## January 22, 2019

<b>STAFF REPORT MEETING OF:</b>	RE:	<b>902-920 Kresson Rd.</b>
	Plan:	MJ-12-1-18
	Municipality:	Cherry Hill
	Applicant:	MiPro Homes, LLC.
	Abuts County Route:	Kresson Rd. (Cr. 671)

**CAMDEN COUNTY PLANNING BOARD  
COUNTY ENGINEER'S REVIEW  
OF SUBDIVISIONS AND  
SITE DEVELOPMENT PLANS**

**COUNTY PLAN:  
MJ-12-1-18**

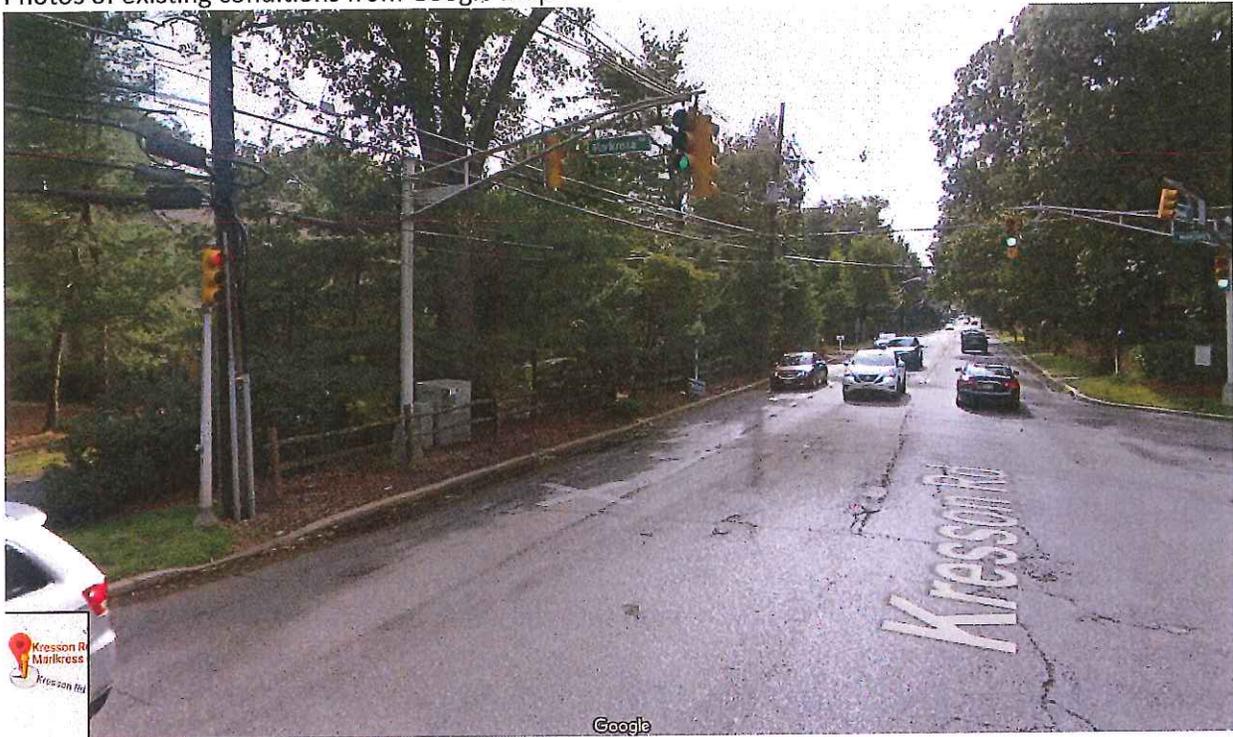
Residential driveway exiting onto Kresson Road (CR 671) from horseshoe driveway on Block 434.01, Lot 10 encroaching onto development property Block 434.01, Lots 11 & 12. Access easement will be created to allow residential horseshoe driveway exiting onto Kresson Road (CR 671) to remain.

Dirt Road behind residential driveway apron running along eastern property line. Dirt Road should be removed.

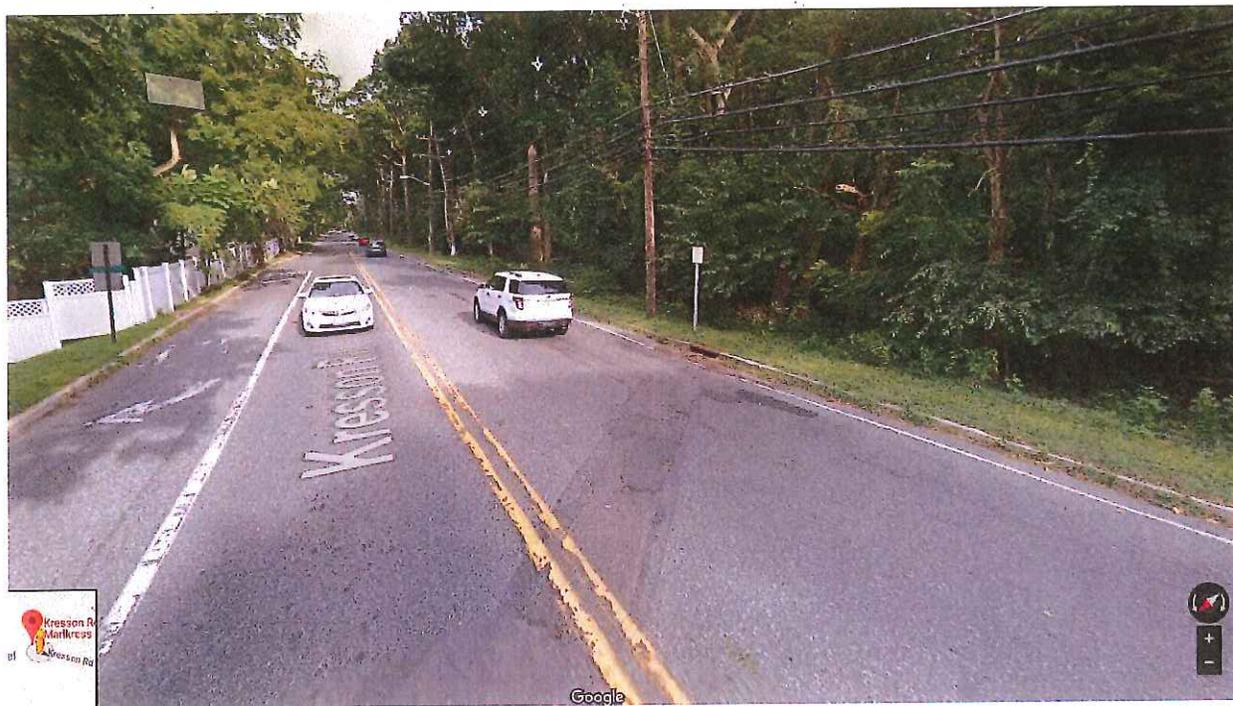
Intersection of Kresson Road and Marlkrass Road. Note location of signal equipment, split rail fence, trees and landscaping in County right of way.

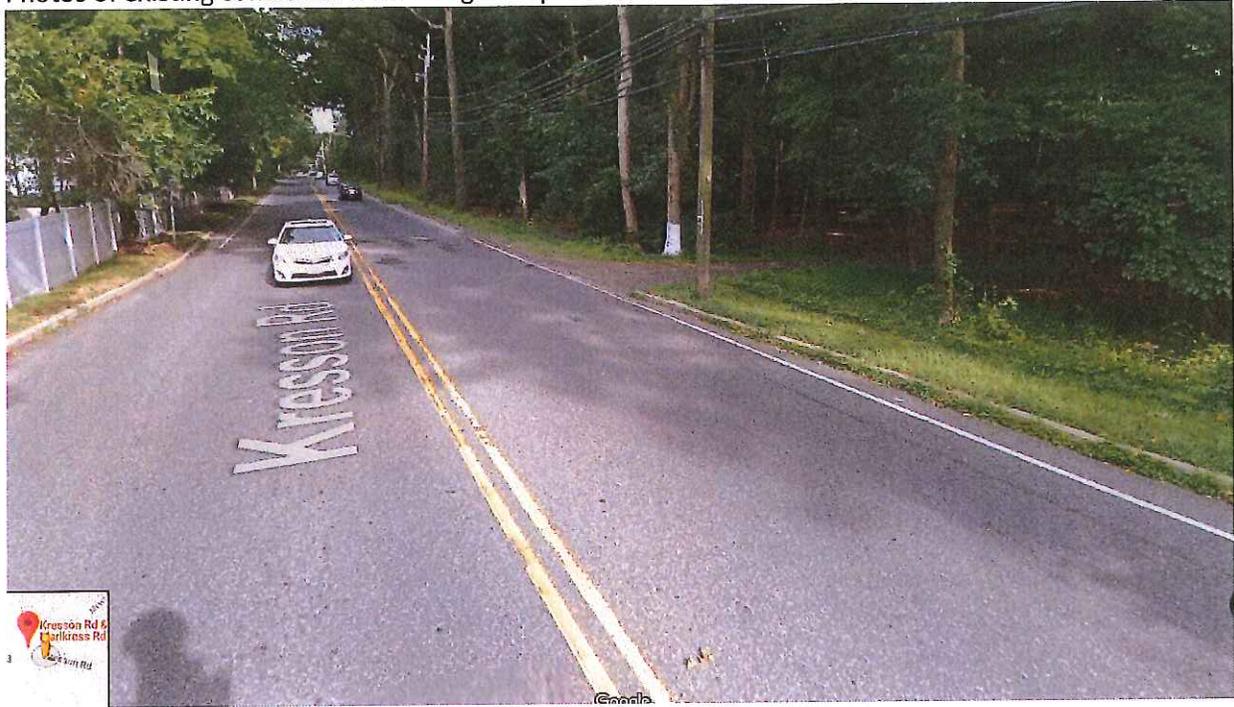
Existing conditions along applicant's frontage on Kresson Road (CR 671). Eastbound traffic has two (2) travel lanes approaching Marlkrass Road (CR 672) intersection, westbound traffic has one travel lane.

Existing residential driveway location. Center of proposed cul-de-sac will be approximately 30 feet to the west or moved 30 feet away from Marlcrest Road intersection.
